Case No. 2025-00064
Summer Shade Solar, LLC
Responses to Siting Board's First Request for Information

SITING BOARD 1-1:

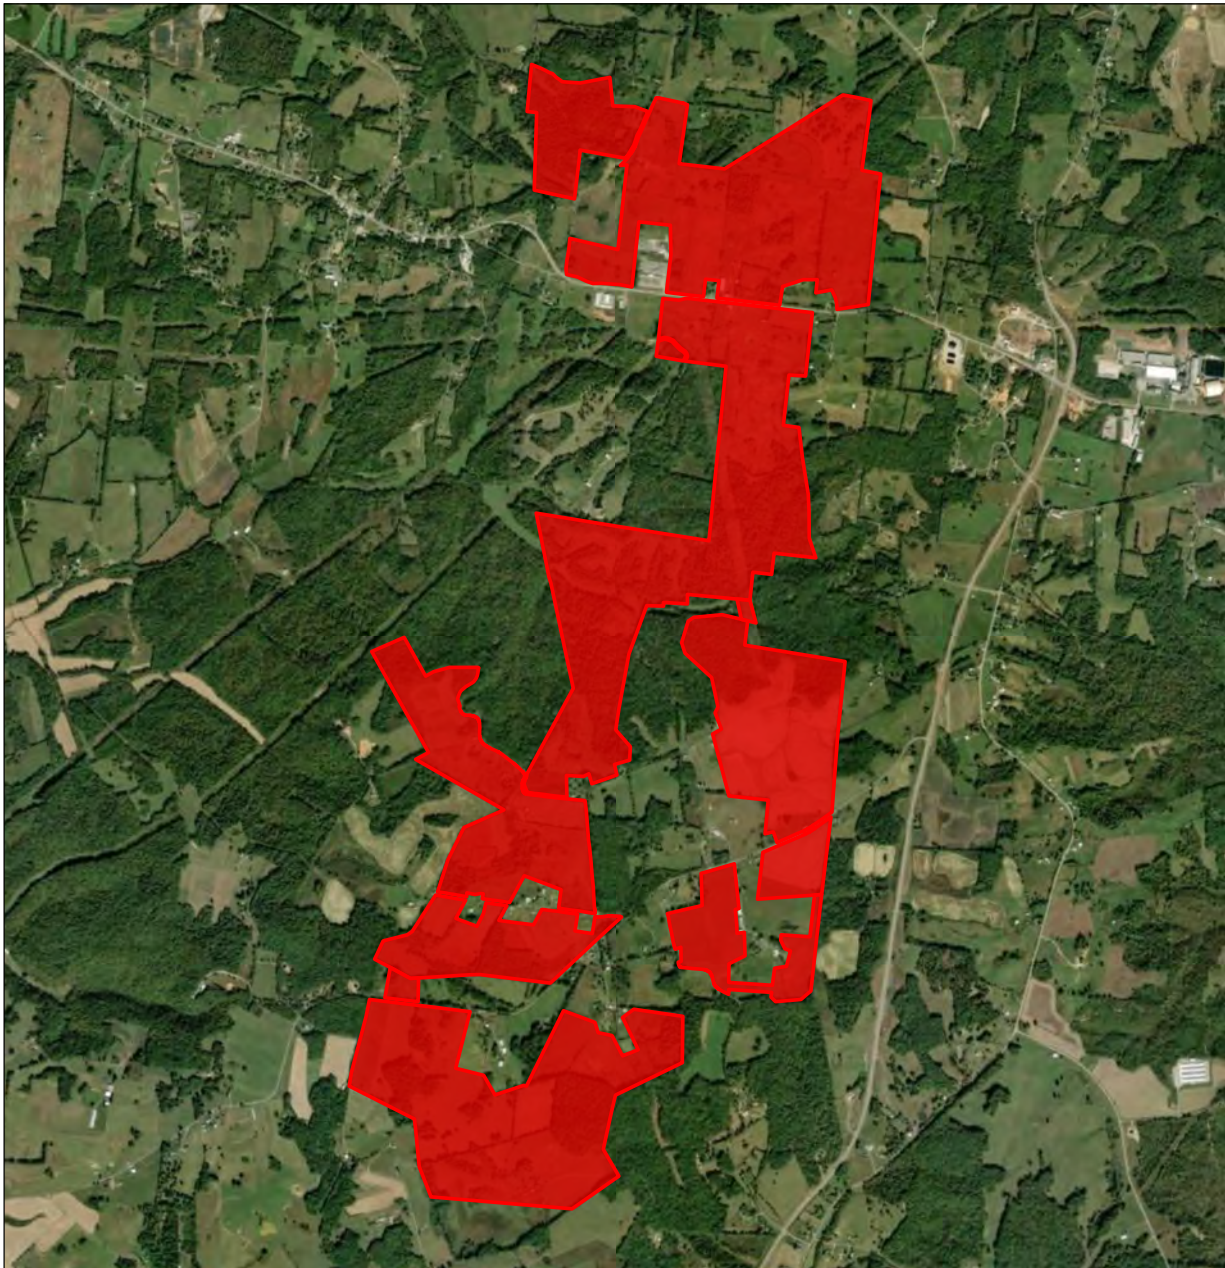
Explain whether construction activities will occur sequentially or concurrently across the project site.

Response: Activities during the first half of construction will occur sequentially. The initial tasks are related to vegetation removal, civil works and initial setting of foundations and trackers. During the second half of construction, all the site will be an active construction site with activities happening in parallel. The main activities during the second half are the installation of modules, electrical connections (Medium and Low Voltage), and testing and commissioning. Tasks will be different in each area of the Project, but there will be activity happening across the entire project site during the second half. Refer to Exhibit "SSHKYSB_CAND27_BasicConstructionChart" in response to Item #27 for an overall perspective of main construction activities, duration, sequence and overlaps.

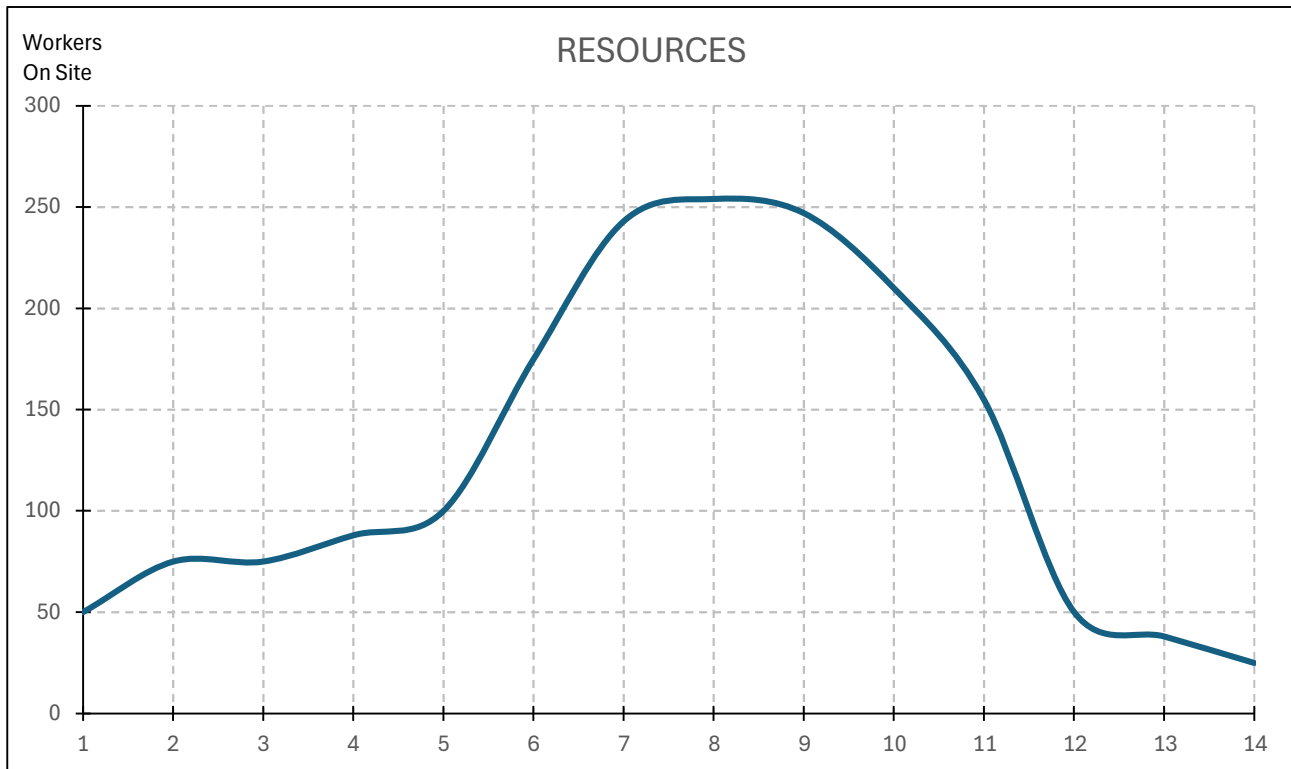
Provide a schedule for the project, starting from the receipt of the proposed certificate of construction to the completion of the project, including the length of each construction phase.

Response: See attached document below.

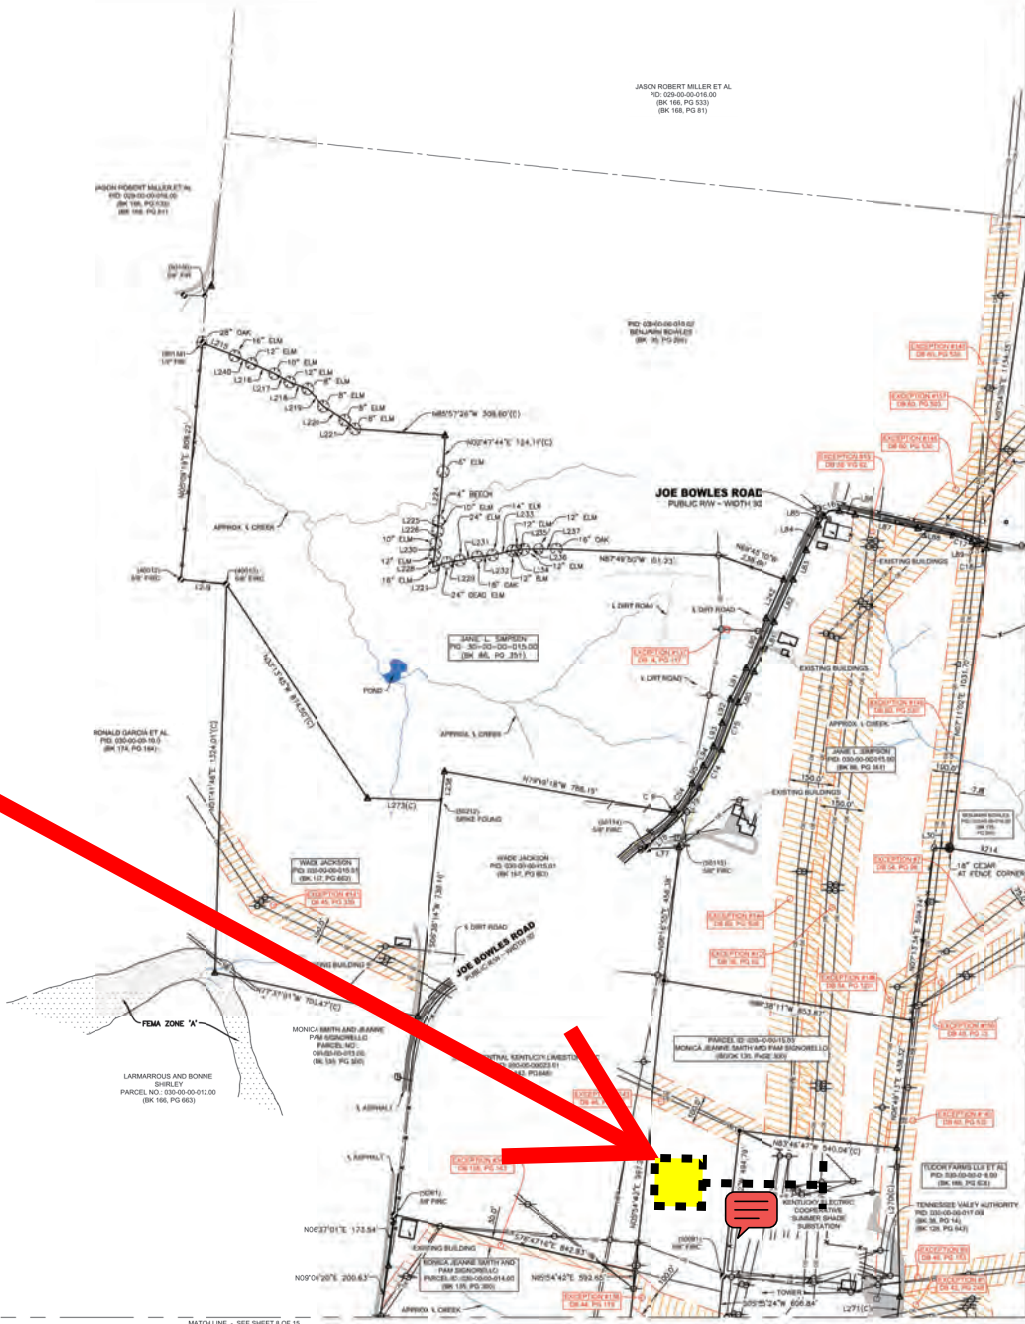
Provide a map showing the existing property lines that the proposed transmission line is proposed to cross.

Response: Please refer to ALTA figure attached for property lines, and to the Updated Preliminary Site Layout in response to Item #39 for the location of the proposed substation and proposed transmission line route. The proposed substation location will be located on parcel ID 030-00-00-15.03. The proposed transmission line will cross from this parcel directly to the parcel owned by East Kentucky Power Cooperative where the existing 161 kV EKPC substation is located. The transmission line is approximately 300 feet and will cross one property line.

Figure 1. Interconnection – Typical transmission line support structure

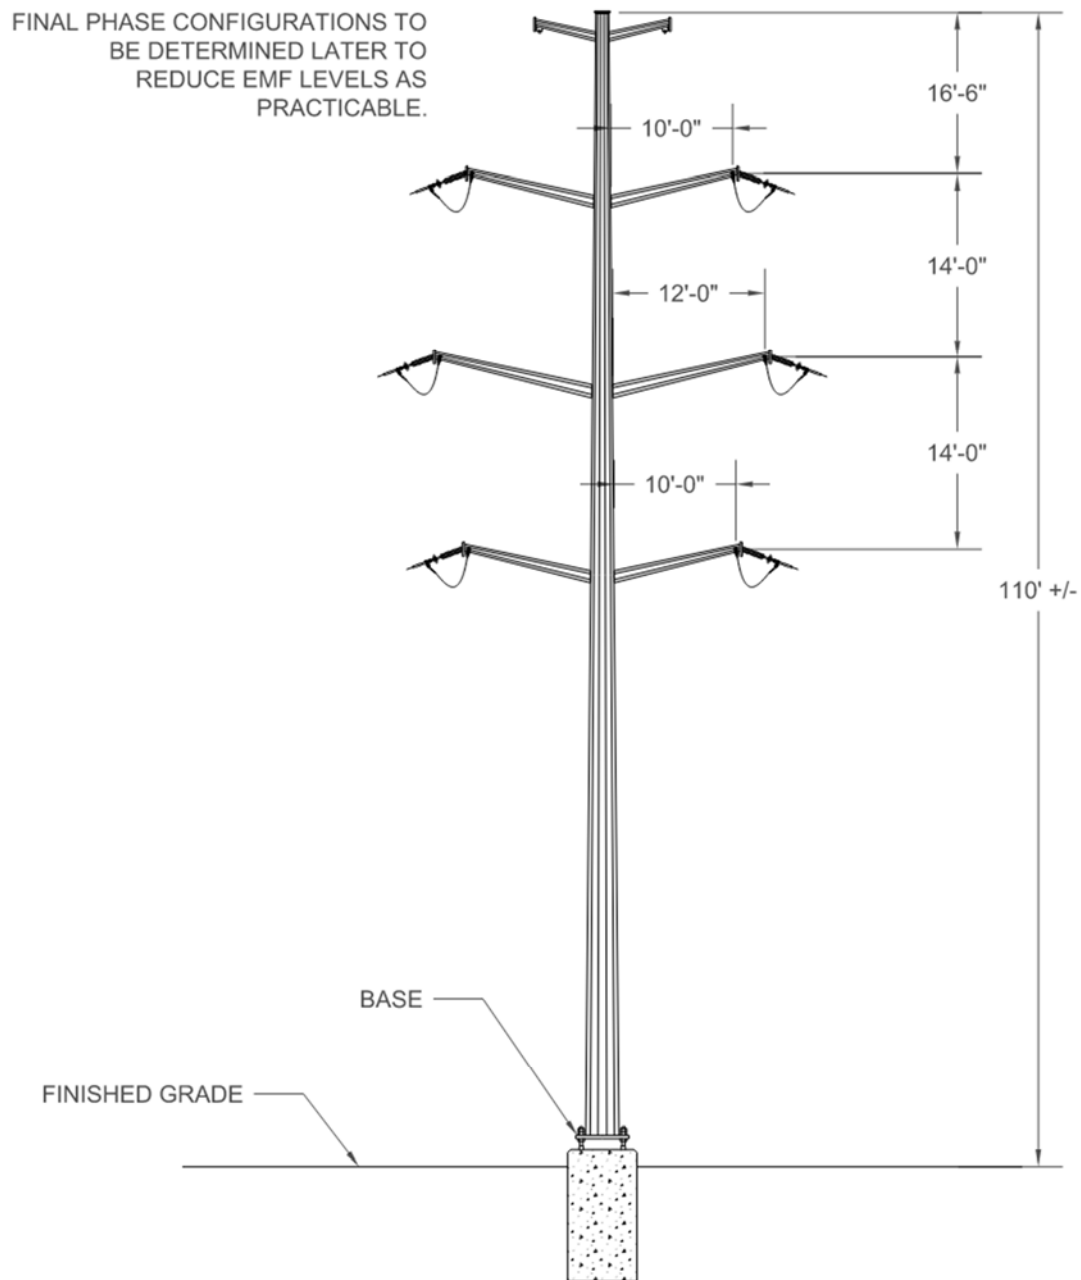
Provide any sketches of the proposed transmission line support structure.
